River Bend Crossing Traffic Impact and Access Analysis (LSC #184140) August 2, 2018

Summary of Comments on LSC Responses to EPC TIS Redline Comments.pdf

Figure 4
**Directional Distribution
of Site-Generated Traffic**
River Bend Crossing (LSC #184140)

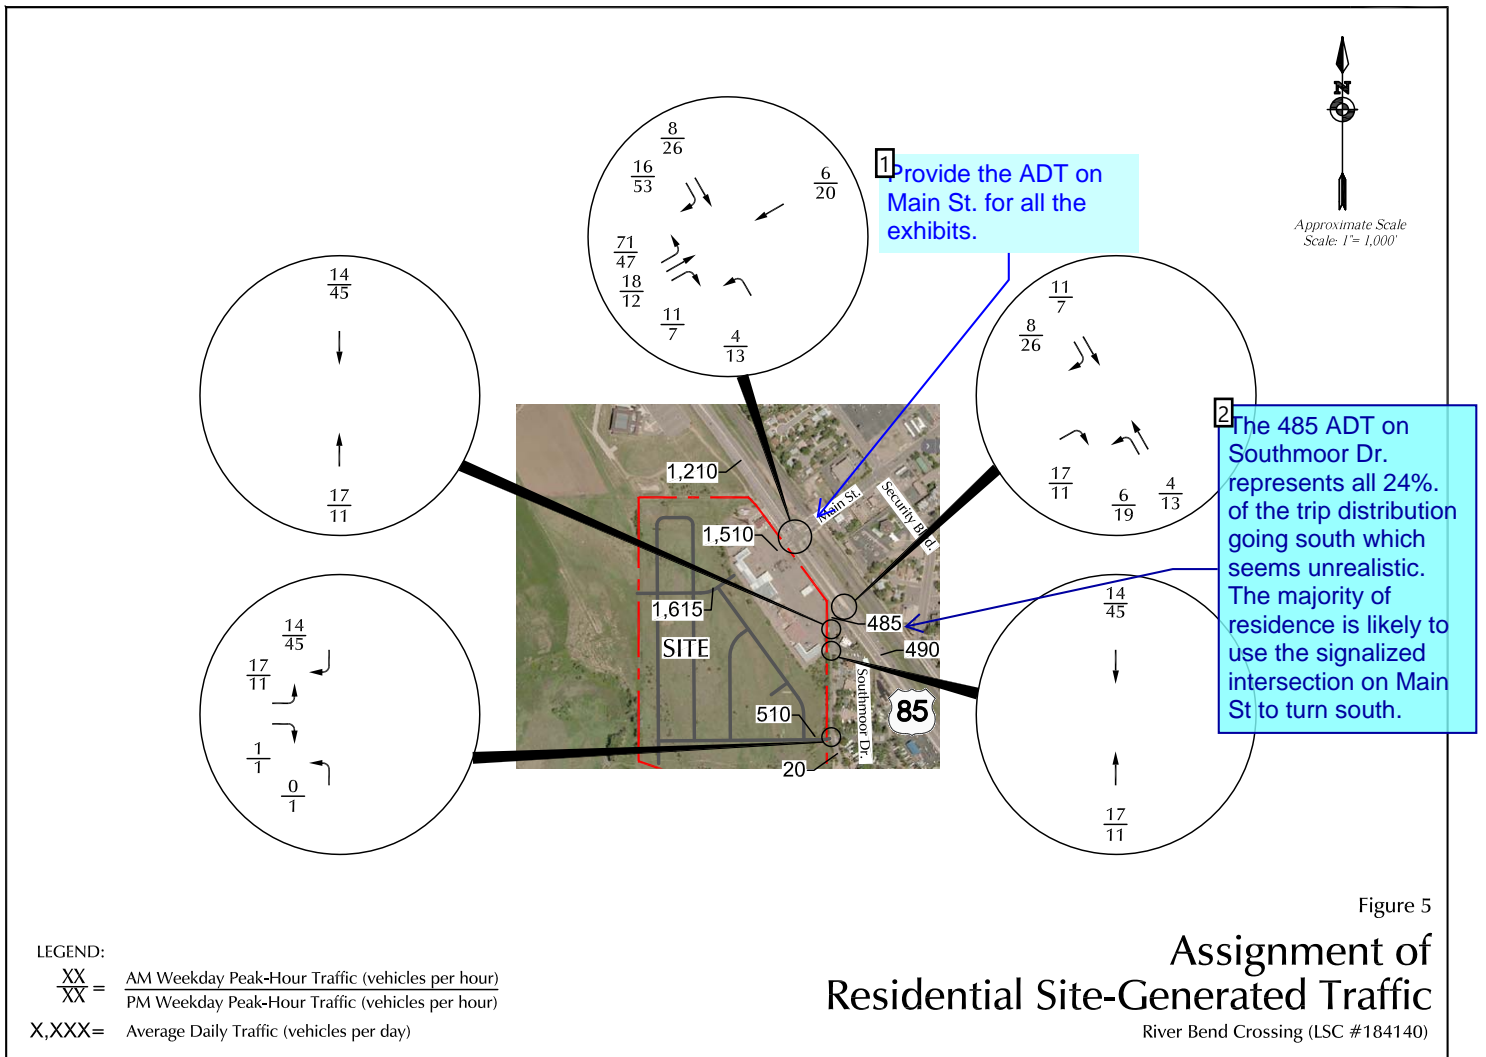
This seems too low given there is an Elementary School and High School to the east.

Identify the % distribution for the Main St entrance going to/coming from the south .

Author: Kirstin Subject: Sticky Note Date: 4/27/2019 12:24:06 PM
the distribution has been revised as requested

Author: Kirstin Subject: Sticky Note Date: 4/27/2019 12:23:47 PM
done

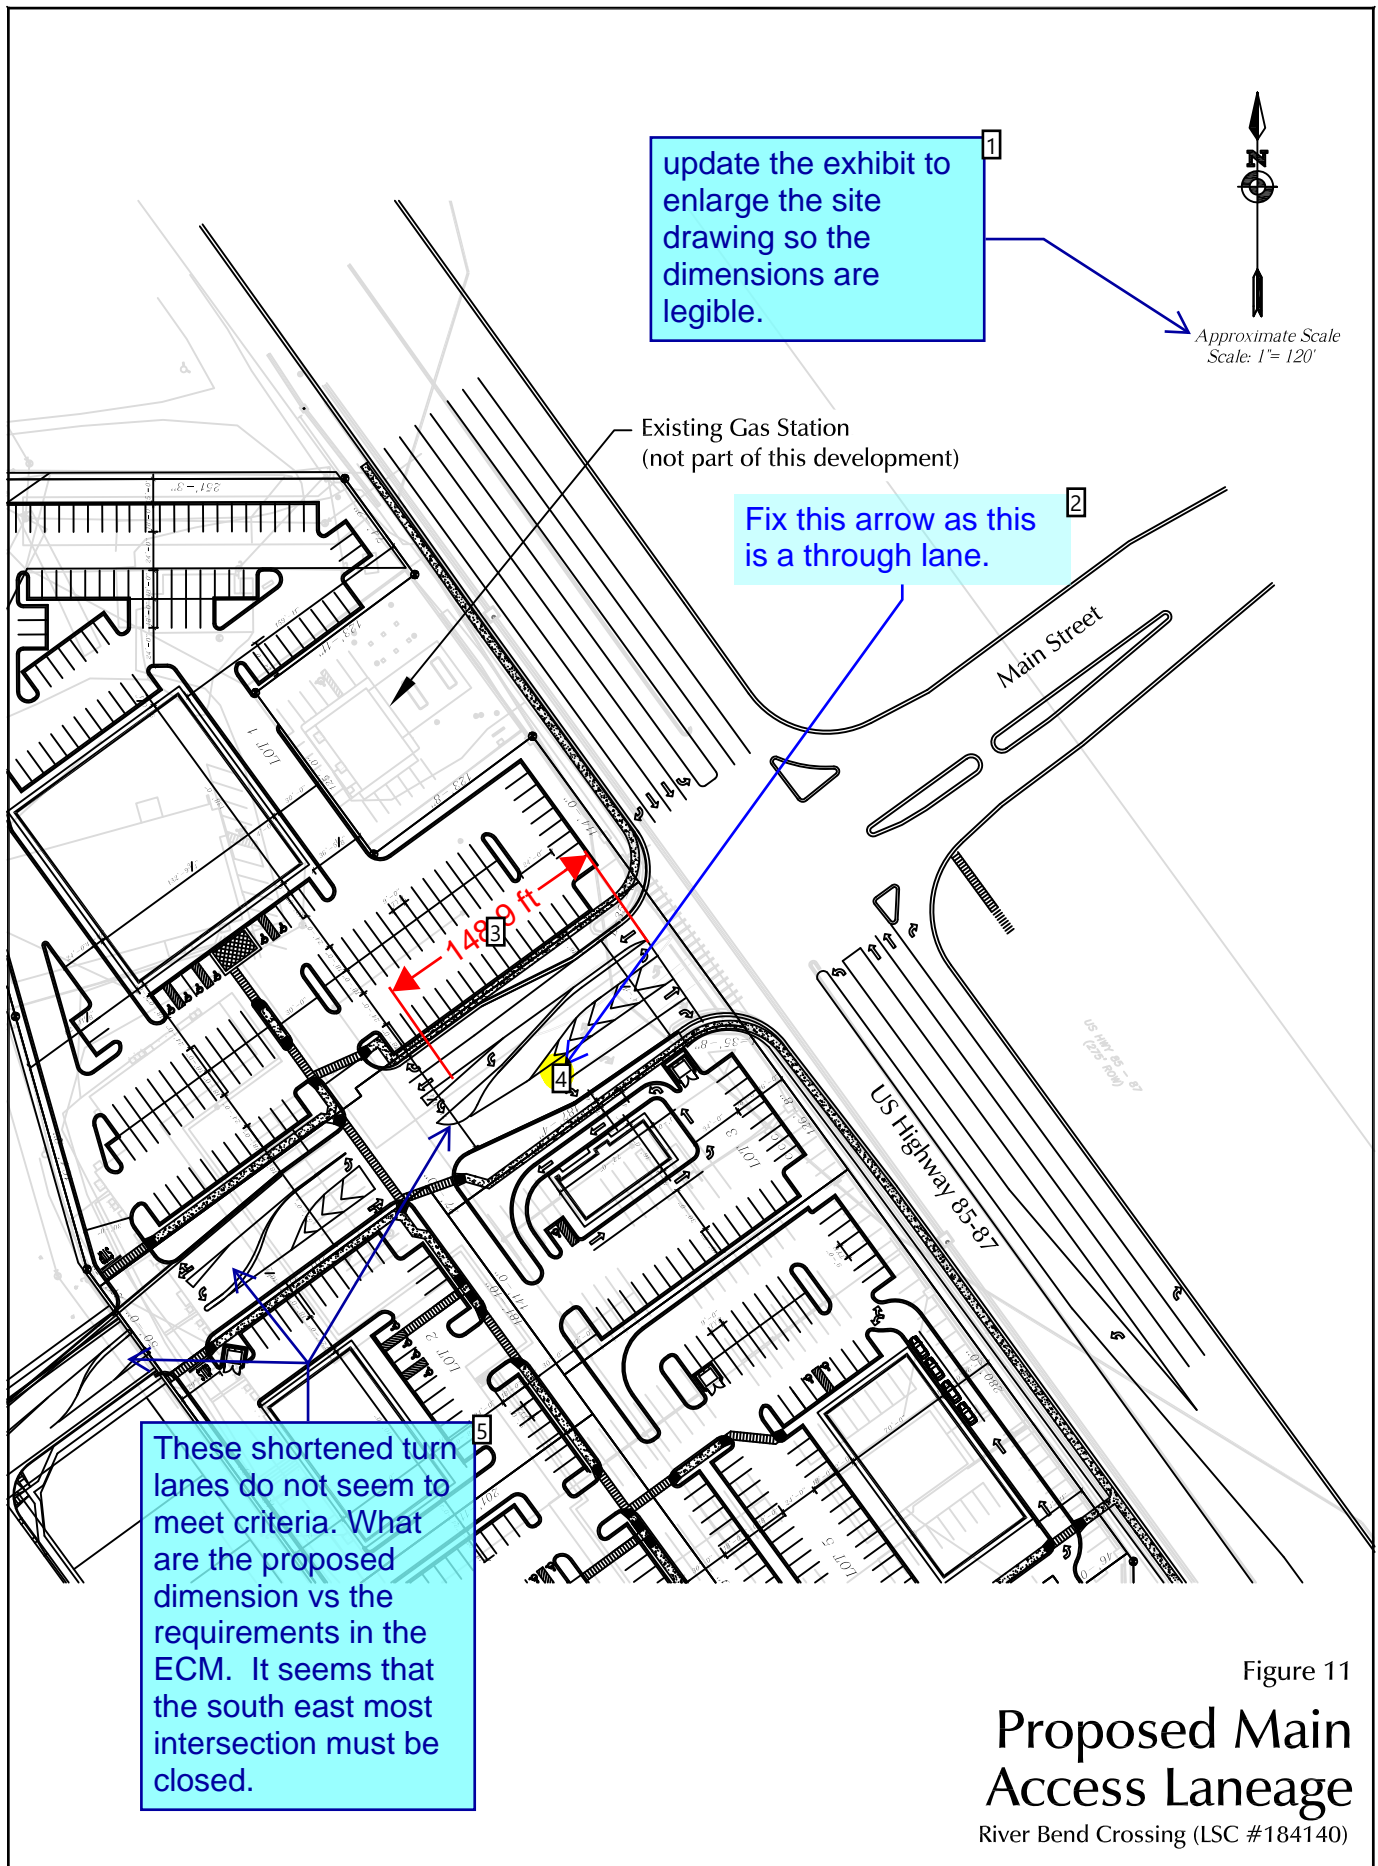
Provide the ADT on Main St. for all the exhibits.

The 485 ADT on Southmoor Dr. represents all 24% of the trip distribution going south which seems unrealistic. The majority of residence is likely to use the signalized intersection on Main St to turn south.

update the exhibit to enlarge the site drawing so the dimensions are legible.

Fix this arrow as this is a through lane.

These shortened turn lanes do not seem to meet criteria. What are the proposed dimension vs the requirements in the ECM. It seems that the south east most intersection must be closed.

Author: Kirstin Subject: Sticky Note Date: 4/27/2019 12:24:14 PM
done

Author: Kirstin Subject: Sticky Note Date: 9/5/2019 5:09:17 PM
The trip assignment has been updated based on this comment and the updated site plan.

Author: Kirstin Subject: Sticky Note Date: 4/29/2019 11:33:30 AM
The exhibit has been updated as requested

Author: Kirstin Subject: Sticky Note Date: 4/29/2019 11:33:40 AM
done

Author: jchodsdon Subject: Sticky Note Date: 9/5/2019 5:05:57 PM
LSC Response: The project team has met with the City of Fountain to discuss this laneage. The laneage has been updated based on that meeting and coordination with CDOT.
